Lower Colorado River Authority 3700 Lake Austin Blvd. Austin, TX 78703

RE: Burnet Quarry

Application #2024-5606 U2 (Update 2) Address: 3221 FM 3509, Burnet, TX 78611

We have reviewed the plans for the referenced permit application. The project proposes the use of Quarry Pits to meet the Performance Standards established by LCRA's Highland Lakes Watershed Ordinance. We have the following comments regarding the plans and application:

C.2

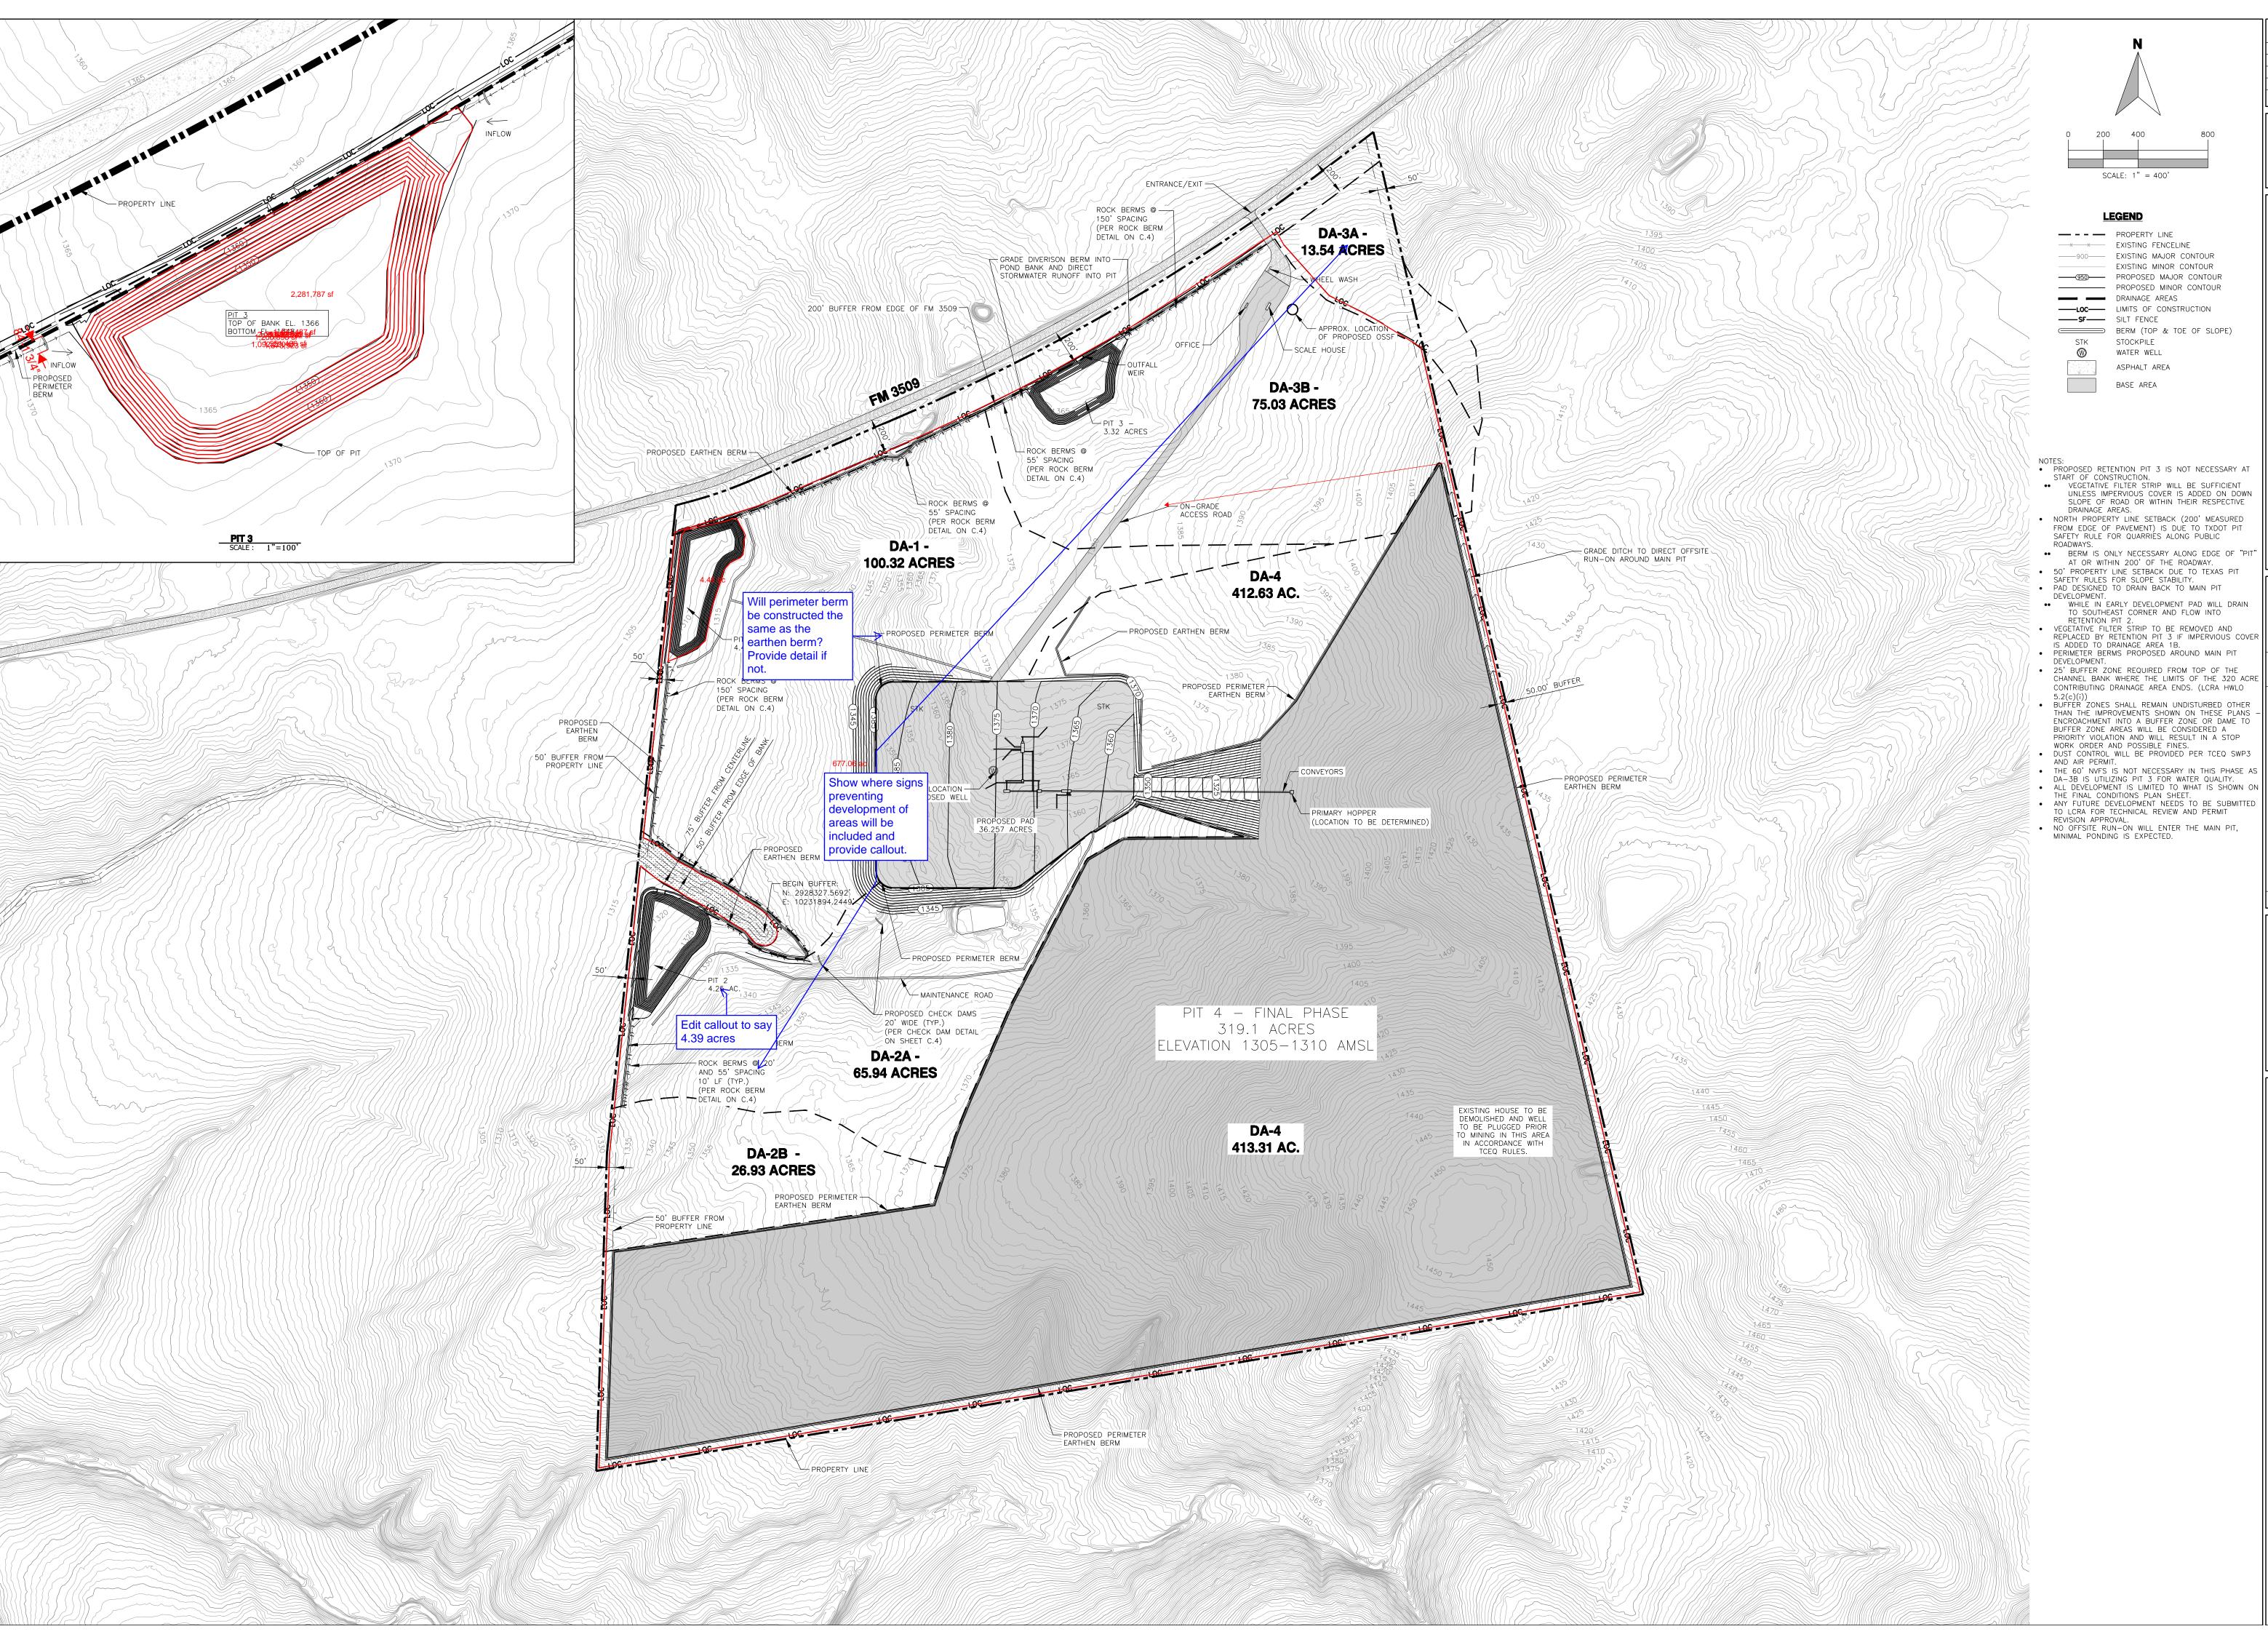
- 7. Add a quantity and pricing for rock berms, check dams, and high service rock berms. Refer to the markups on sheet C.2 for more information.
 - U1- Comment partially addressed. Based on LCRA's rock berm spacing requirements for varying slopes, the rock berm quantity will need to be updated. Please see markup on sheet 1 referencing the spacing revisions. Are these rock berms temporary or will they remain in place once the initial phase of construction is completed?

- U2- Comment partially addressed. I measured 1040 LF of Rock Berms. Please revise and update the quantity within the cost estimate.
- 8. All proposed work, including the final conditions need to be included within the limits of construction. The total acreage within the limits of construction needs to be the amount of seeding proposed (Seed mixture+ Hydromulching= Acreage within limits of construction).

- 18. It is stated that two Gorman pits are proposed but the initial conditions plan sheet (C.2 of C.4) shows 3 pits with a total acreage of 6.99 acres.
 - U1- Comment partially addressed. The hydrologic report states "approximately 4.6 acres" within the Post-development conditions but the plan sheets are showing 6.9 acres. Please revise.
